MASONRY WALL DESIGN (B-59)

FLORIDA POWER AND LIGHT COMPANY
ST. LUCIE UNIT 1

TER-C5506-244

TECHNICAL EVALUATION REPORT

Figure 1. Typical Construction Details

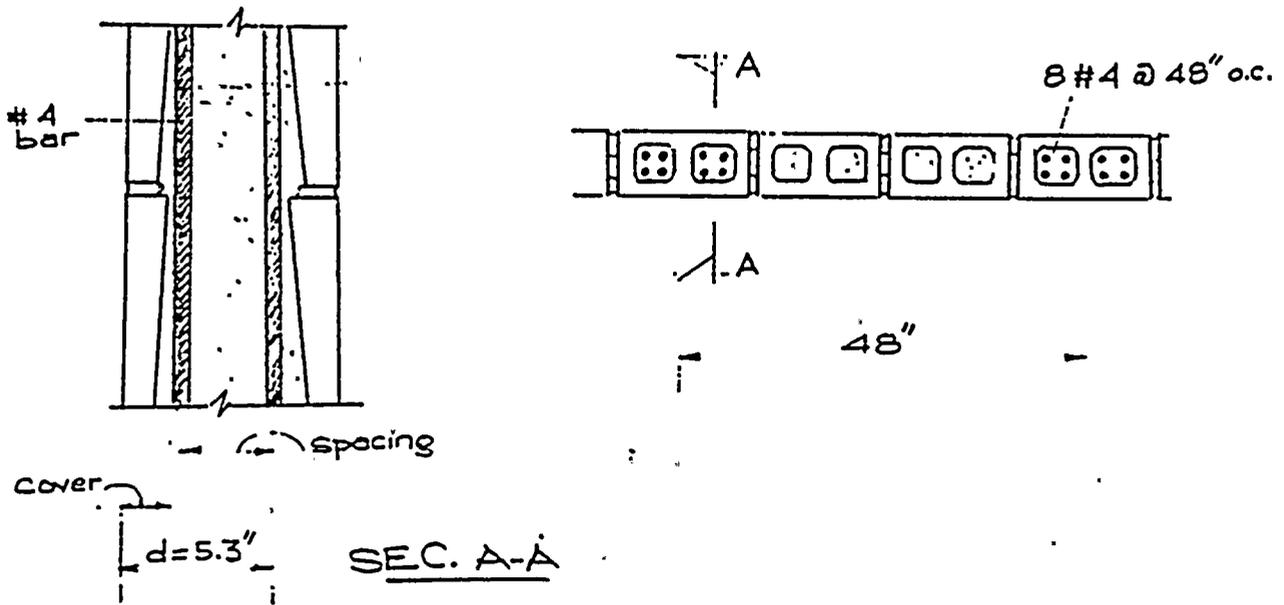
Indicate the number of walls of the stack bond type and provide a sample calculation to obtain moment and shear stresses of a typical stack bond wall.

The Licensee indicated 65 walls were constructed using stack bond construction. The walls are vertically reinforced with eight No. 4 bars at 4-ft intervals and horizontally reinforced with Dur-O-Wal every course. The walls are fully grouted. The top support is restrained by clip angles on both sides, and the bottom support is restrained by dowel action. Typical construction details are illustrated in Figure 1. A sample calculation was provided for wall 34. Wall 34 is 16 ft high, 17 ft long, and 12 in thick, and was reinforced by eight No. 4 bars at 4-ft intervals. The seismic accelerations are:

A review of the calculation indicated that the Licensee's approach is technically adequate. Therefore, the Licensee's response is considered satisfactory and in compliance with the SGEB criteria.

SKETCHES OF WALL MODIFICATIONS

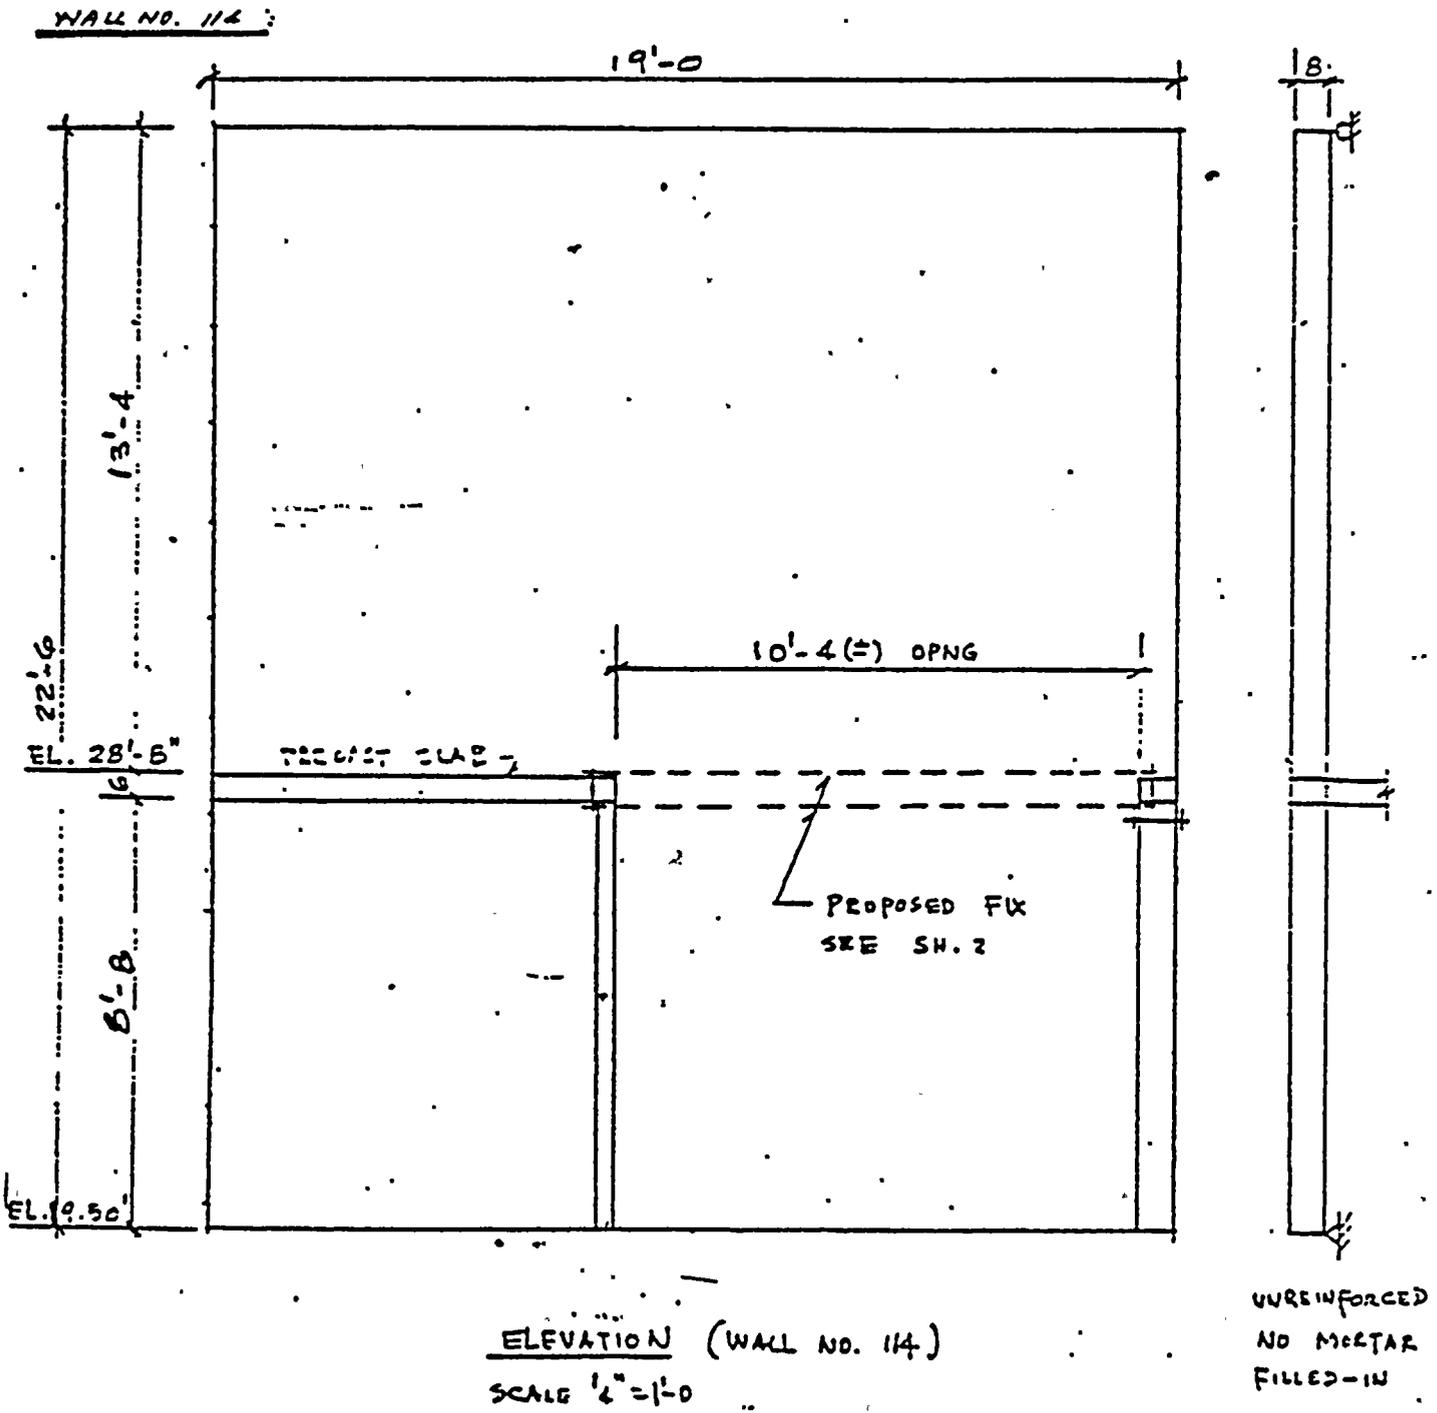
Provide sample drawings of wall modifications, and clarify whether the modified walls were qualified under working stress conditions.

The Licensee provided sketches of sample wall modifications and confirmed that all modified walls were qualified under working stress conditions.

According to Reference 3, the modifications include the replacement of missing clip angles, the addition of steel reinforcing members to provide support and to reduce the span length of the wall, and clip angle reinforcement at top edge supports. Appendix B of this report presents the sketch of the typical wall modifications.

Based on the review of modification techniques and the fact that all modified walls were qualified under the SGEB criteria, it is concluded that the Licensee's response is satisfactory and in compliance with the SGEB criteria.
